The Commission has issued the enclosed Amendment No. 37 to Facility Operating License No. NPF-2 and Amendment No. 27 to NPF-8 for the Joseph M. Farley Nuclear Plant, Unit Nos. 1 and 2, respectively. The amendments consist of changes to the Technical Specifications in response to your application dated October 13, 1983.

The amendments consist of changes to the Technical Specifications to allow operation with a slightly positive moderator temperature coefficient at low power levels and an increased hot channel factor limit below full power.

JOSEPH M. FARLEY NUCLEAR PLANT, UNIT NO. 1

SAFETY EVALUATION BY THE OFFICE OF NUCLEAR REACTOR REGULATION
RELATED TO AMENDMENT NO. 37 TO FACILITY OPERATING LICENSE NO. NPF-2
AND AMENDMENT NO. 27 TO FACILITY OPERATING LICENSE NO. NPF-8

Figure 2.1-1 Reactor Core Safety Limit
Three Loops in Operation

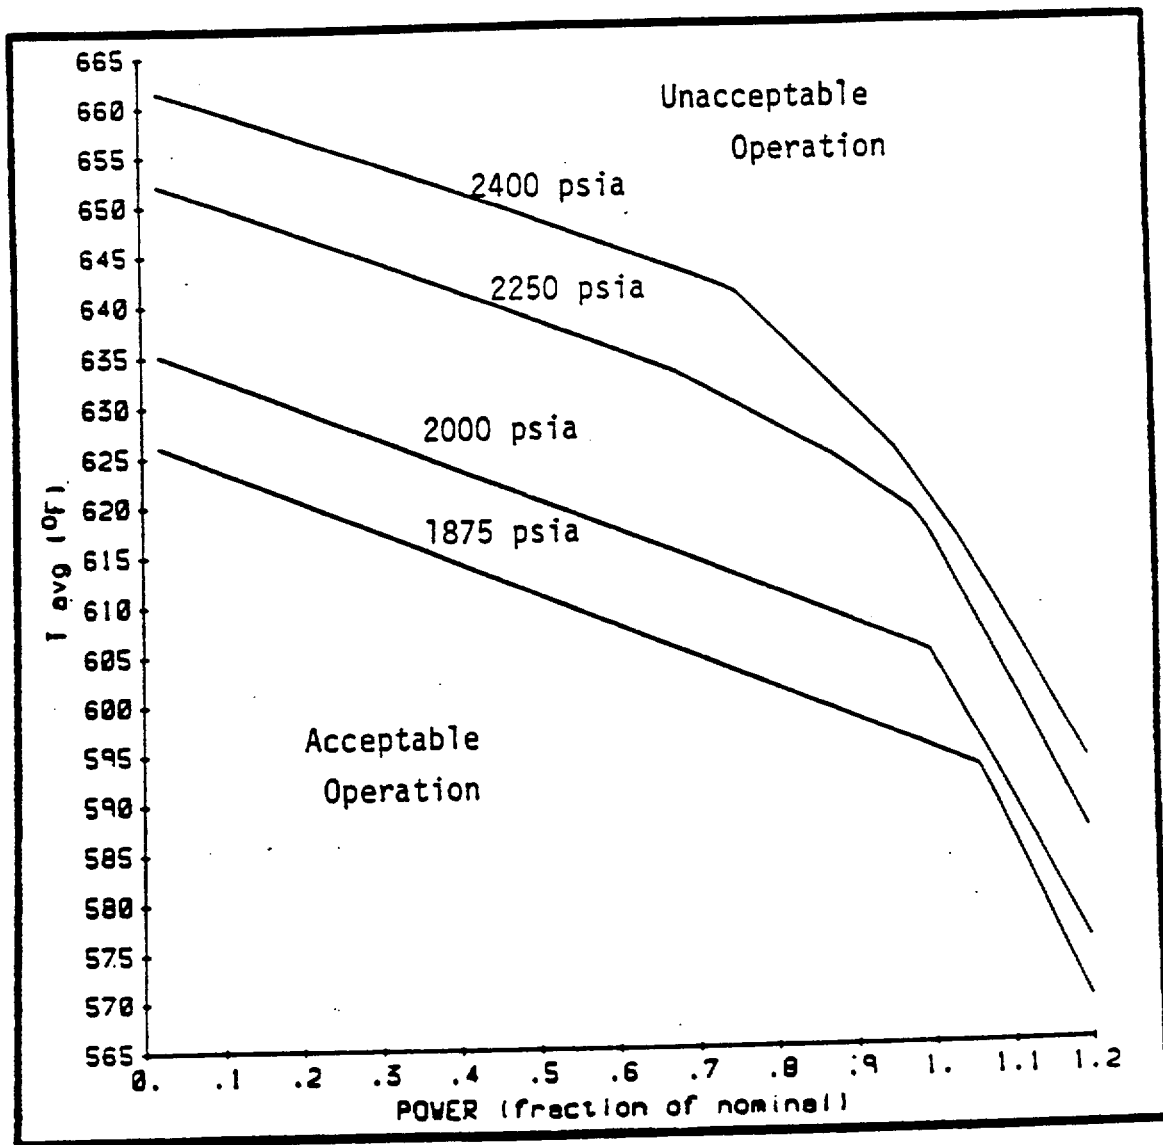
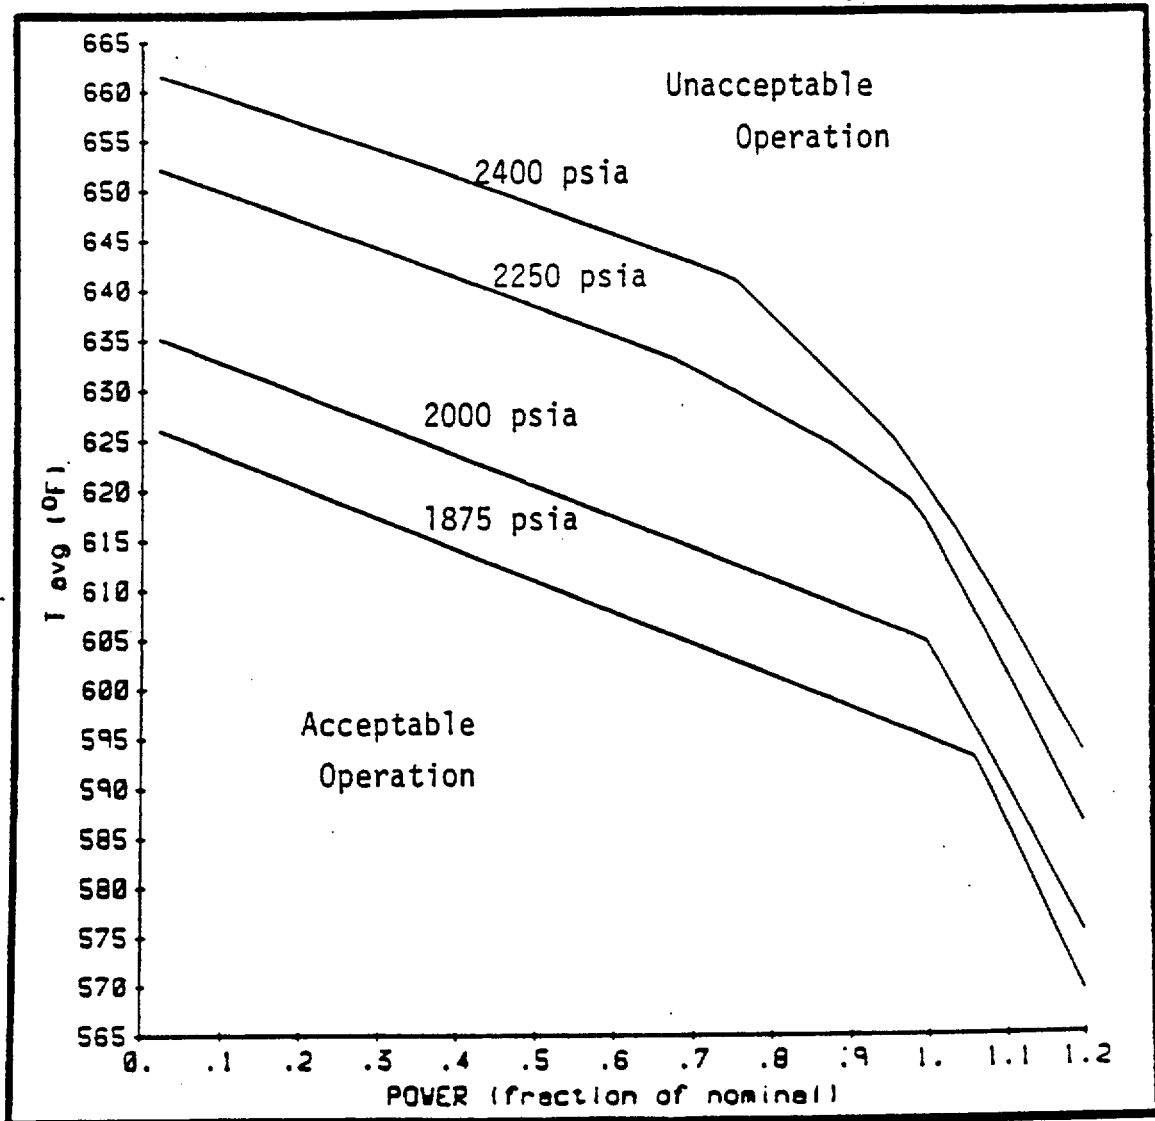
- (3) The overpower and overtemperature ΔT setpoints defined in Specification Table 2.2-1 were revised in order to optimize the available operational margin that exists between the setpoints and the new core safety limits (Figure 2.1-1) which were established due to the above-mentioned $F_{\Delta H}^N$ change. The constants in these ΔT setpoints were modified according to the setpoint methodology accepted for all previous Westinghouse cores and described in WCAP-8745, "Design Bases for the Thermal Overpower ΔT and Thermal Overtemperature ΔT Trip Functions." Those incidents which rely on these trips were reanalyzed to confirm that the limiting conditions and safety criteria are met. Therefore, the revised overpower and overtemperature ΔT protection setpoint modifications are acceptable.

The curves of Figures 2.1-1 and 2.1-2 show the loci of points of THERMAL POWER, Reactor Coolant System pressure and average temperature for which the minimum DNBR is no less than 1.30, or the average enthalpy at the vessel exit is equal to the enthalpy of saturated liquid.

These curves are based on an enthalpy hot channel factor, $F_{\Delta H}^N$, of 1.55 and a reference cosine with a peak of 1.55 for axial power shape. An allowance is included for an increase in $F_{\Delta H}^N$ at reduced power based on the expression:
